Determination 2009/104

Refusal to issue a building consent for a house with insulated concrete walls at 11 York Road, Riversdale, Southland

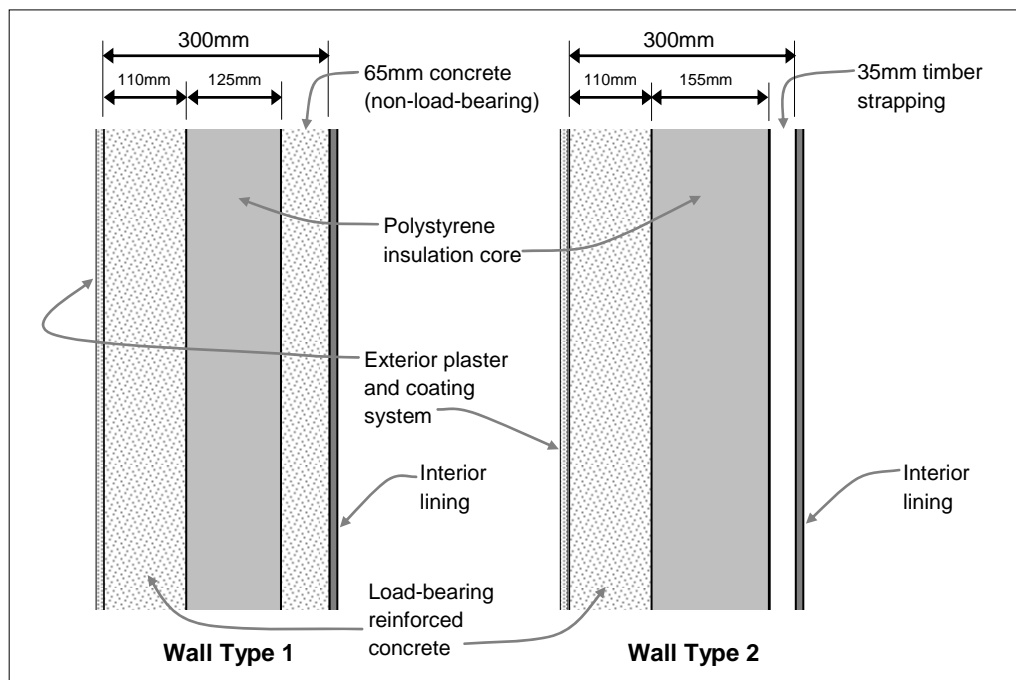
- 2.3 The consent documents detail double glazed windows and doors, and 100mm polystyrene beneath the floor slab. The specification calls for a type of glass wool ceiling insulation that has an R-value of 3.6. The following shows the general wall system:

- 2.4 The proprietary ‘sandwich’ system (“the concrete wall system”) provides 300mm thick composite walls, comprising an outer load-bearing layer of reinforced concrete against a core of expanded polystyrene. The concrete is sprayed on-site to provide a continuous wall system, with the polystyrene connected to the under-slab polystyrene
- 2.5 The concrete wall system supplier provides a general range of walls with varying thicknesses and thermal qualities. The supplier has had the range of wall types assessed by a product assessment company (“the product assessor”) as complying with relevant clauses of the Building Code⁴.
- 2.6 I note that this compliance assessment does not include Clause E2 in relation to architectural detailing such as windows, doors and other penetrations.
